Safety Bulletin

Bulletin No: ORSA002A

Ride Type: Orbiter (aka Typhoon, Predator)

Purpose: Inspection of top center hub area.

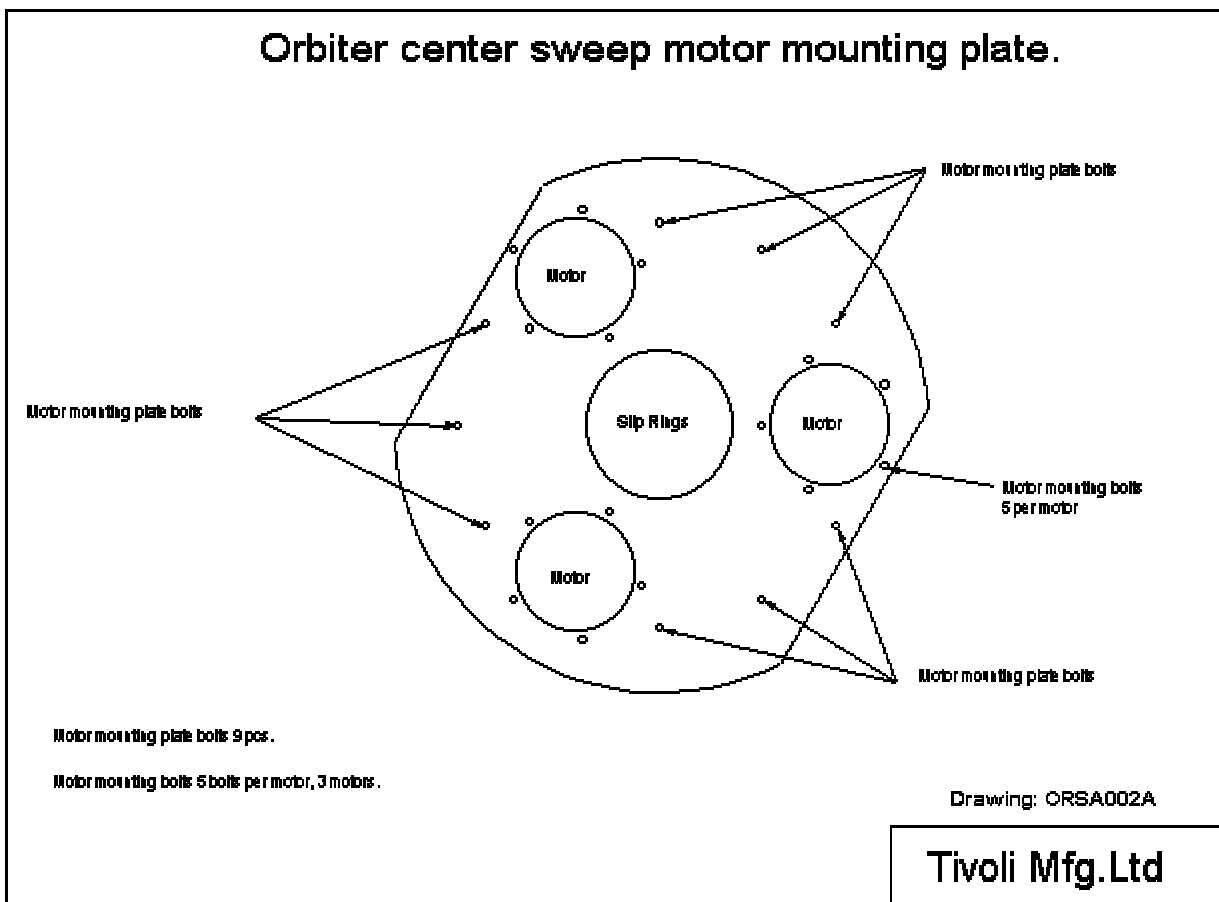
- **Replace all nine (9) bolts securing motors mounting plate to hub.**
 - 9 – 12mm x 45mm bolts spread equal distance around outside parameter of plate. See Attached drawing ORSA002A (See Attached)

Bolt Specification for three motors and motor mounting plate.

Bolt: Hex head, 12 mm x 45 mm x 1.75, grade 8.8, partial thread, black finish. Ref: DIN 931 / ISO4014

Washers: 12 mm, flat hardened washers, 13 mm ID, 24 mm OD, 3 mm thick. C45. Ref: DIN 6916

Tightening Torque Requirements: Tighten bolts to 65 ft-lbs.
